# Claremont Business Park 2 Filing No. 1 ). 3

## STREET IMPROVEMENT PLANS (INCLUDING STORM SEWER)

APRIL 2020

**Claremont Business Park 2 Filing No. 1**  
**STREET IMPROVEMENT PLANS**  
 PROJECT NO. 44-037 FILE: \avg\Const\Draw\Street & Storm Plans\SIO3.dwg DATE: 04/28/2020  
 DESIGNED BY: GW SCALE: SHEET 3 OF 12  
 DRAWN BY: CLP HORIZ: 1"=50' SIO3  
 CHECKED BY: VAS VERT: 1"=5'

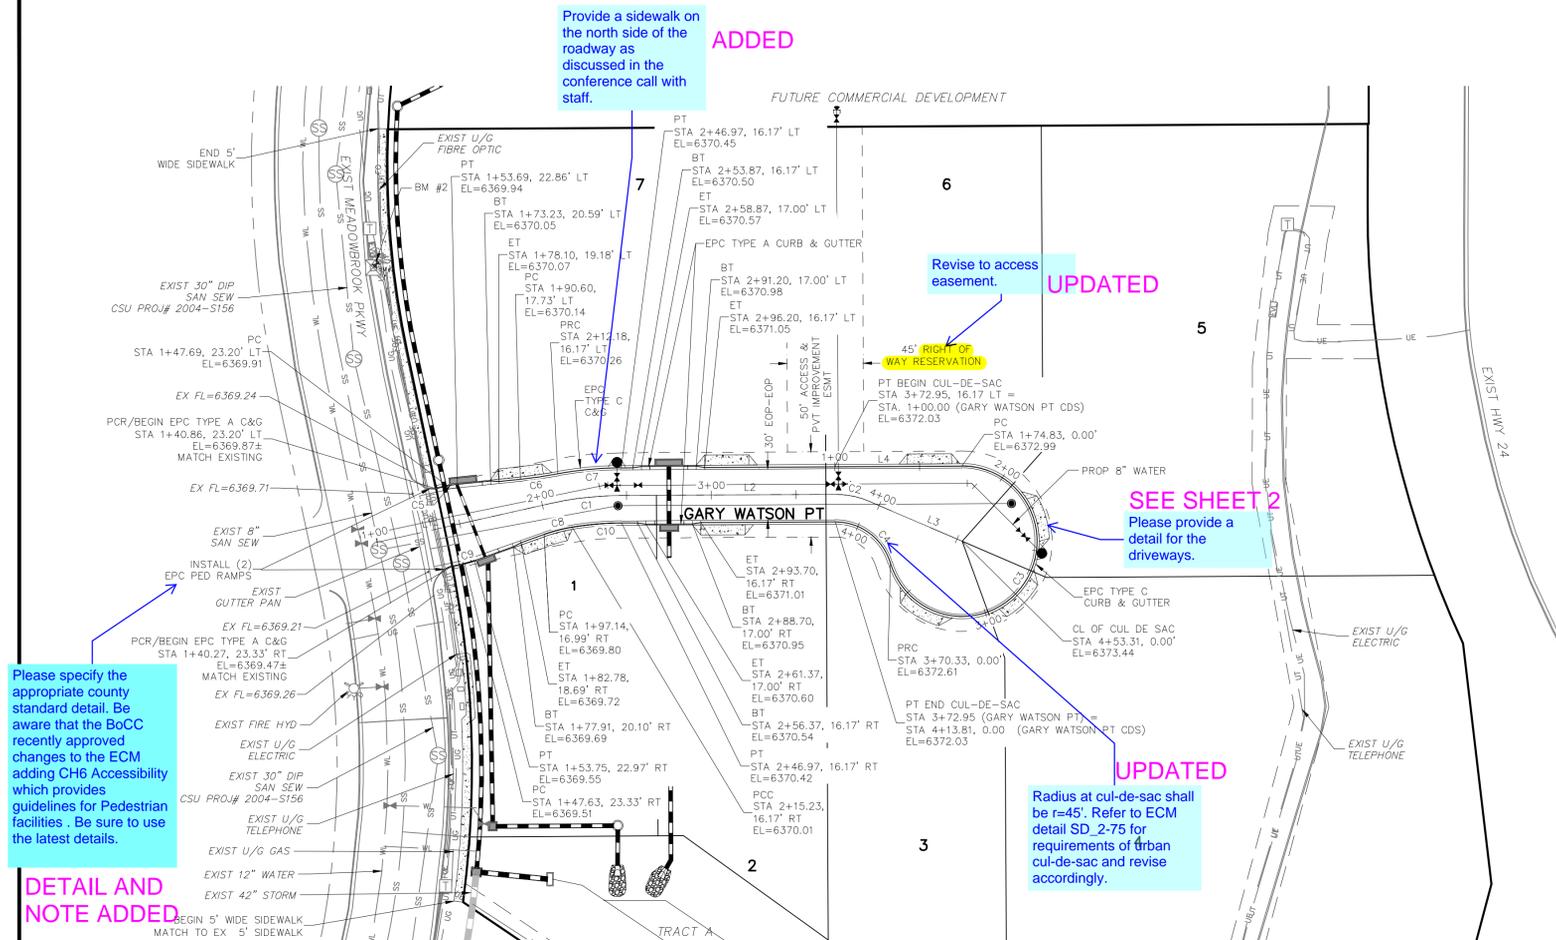
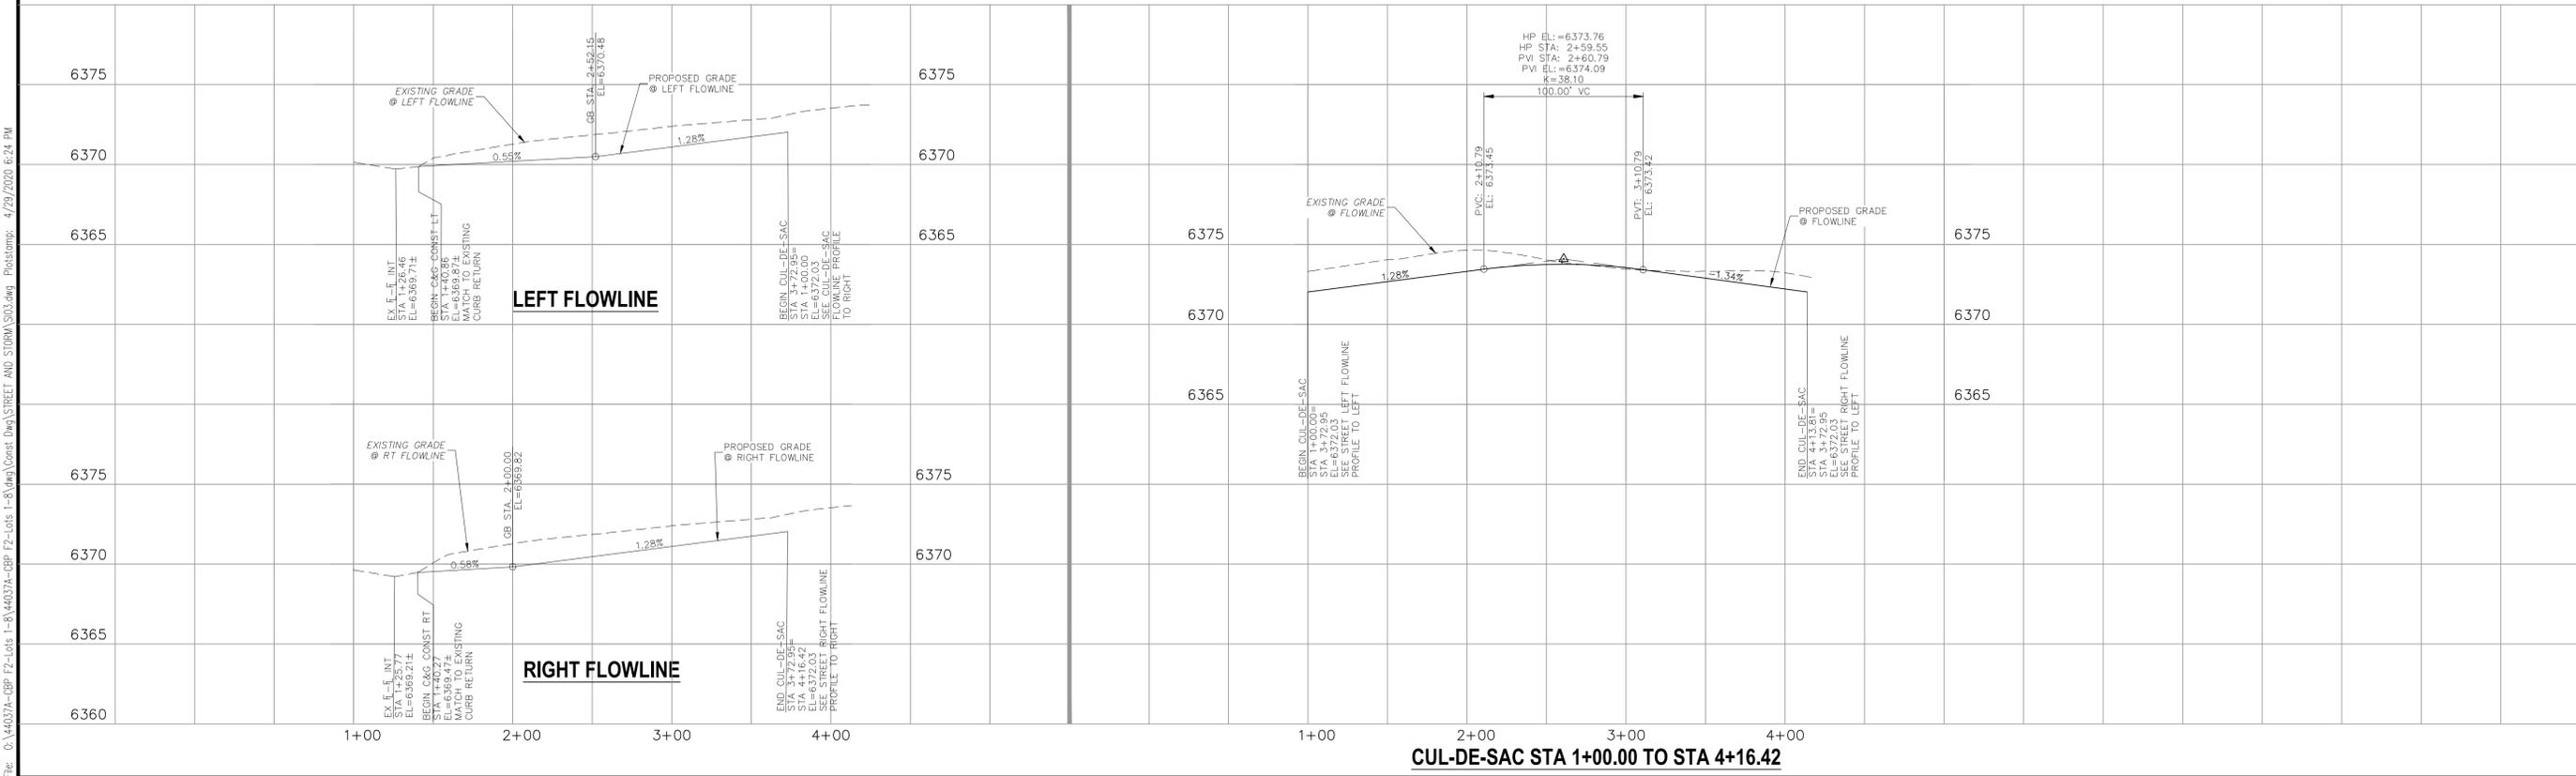
Please specify the appropriate county standard detail. Be aware that the BoCC recently approved changes to the ECM adding CH6 Accessibility which provides guidelines for Pedestrian facilities. Be sure to use the latest details.

DETAIL AND NOTE ADDED

**Claremont Business Park 2 Filing No. 1**  
**STORM SEWER PLAN & PROFILE**  
 PROJECT NO. 44-037  
 DATE: 04/28/2020  
 SCALE: HORIZONTAL: N/A VERTICAL: N/A  
 DESIGNED BY: GW  
 DRAWN BY: CLP  
 CHECKED BY: VAS  
 SHEET 6 OF 12  
 ST02

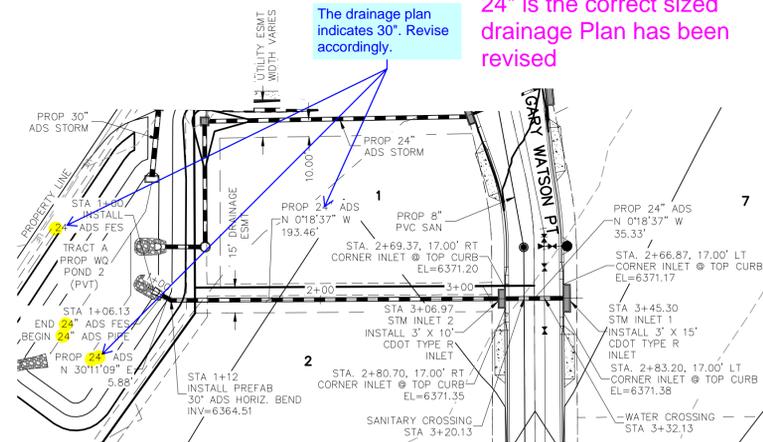
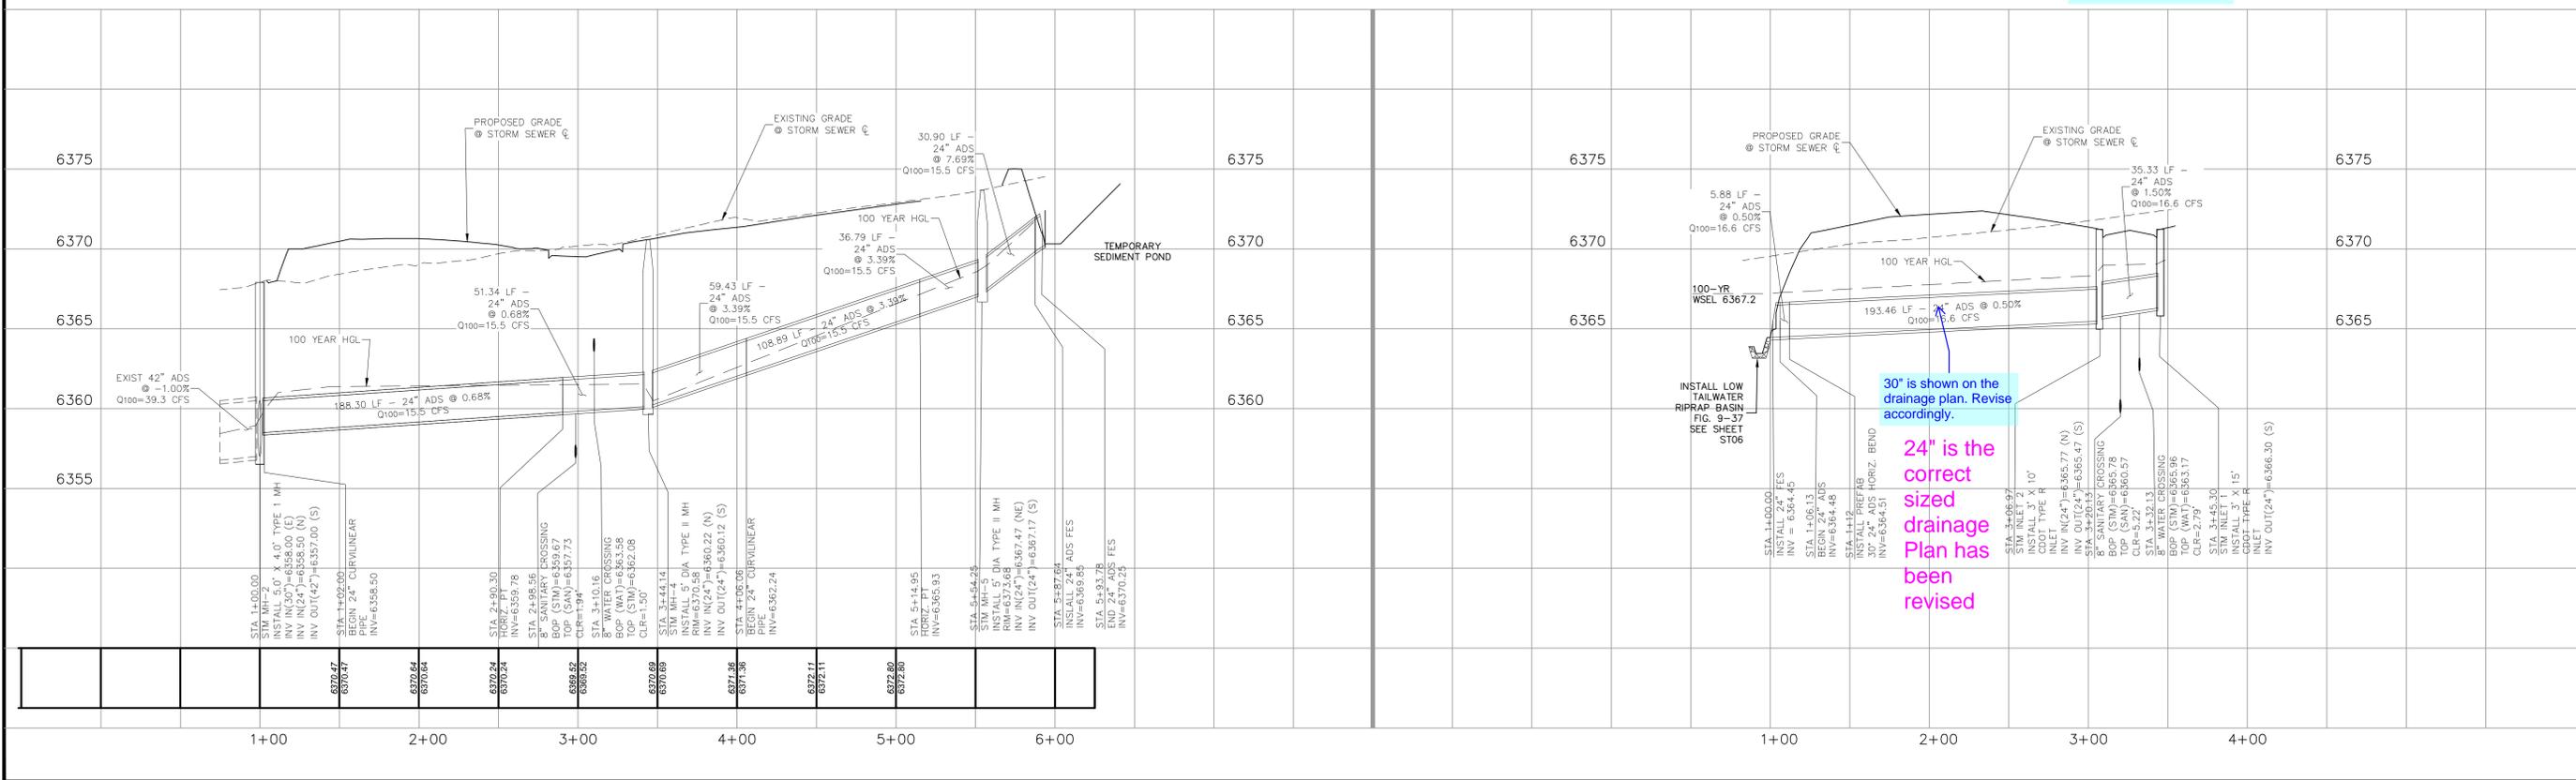
The drainage plan indicates a 36" storm sewer to be removed. Revise accordingly.

The drainage plan indicates 30". Revise accordingly.

added  
Identify the vertical scale

30" is shown on the drainage plan. Revise accordingly.

24" is the correct sized drainage Plan has been revised

24" is the correct sized drainage Plan has been revised

**Claremont Business Park 2 Filing No. 1**  
**STORM SEWER PLAN AND PROFILE**  
 PROJECT NO. 44-037  
 DATE: 04/28/2020  
 SCALE: HORIZONTAL: N/A VERTICAL: N/A  
 DESIGNED BY: GW  
 DRAWN BY: CLP  
 CHECKED BY: VAS  
 SHEET 7 OF 12  
 ST03

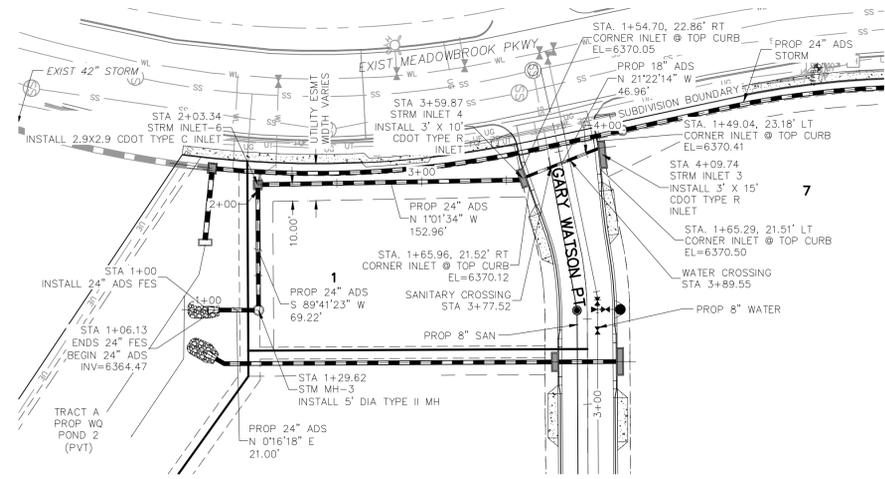
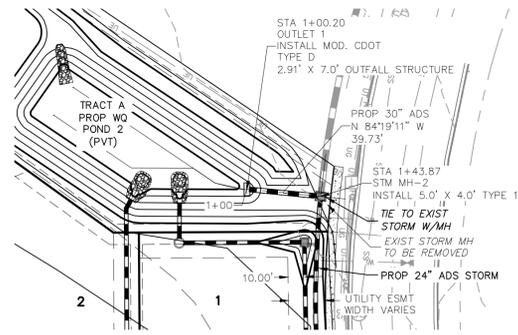
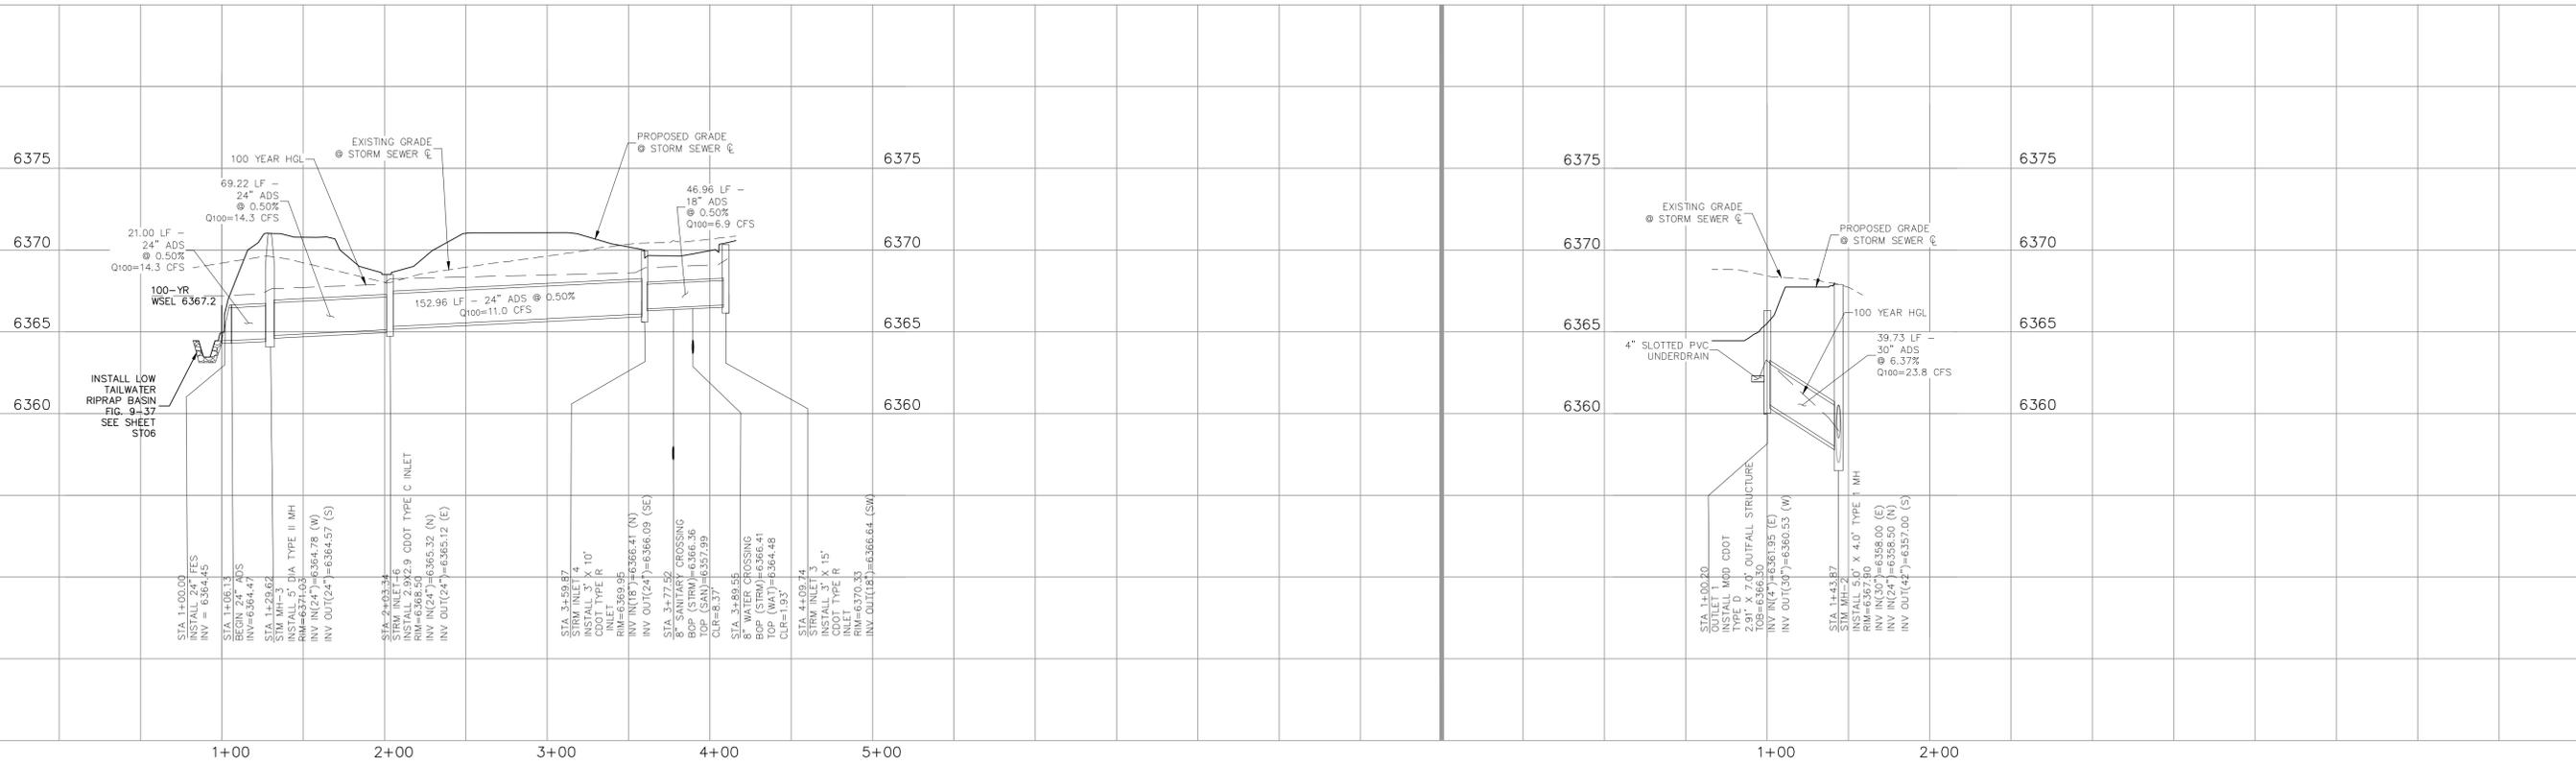
added  
 Please also identify the vertical scale
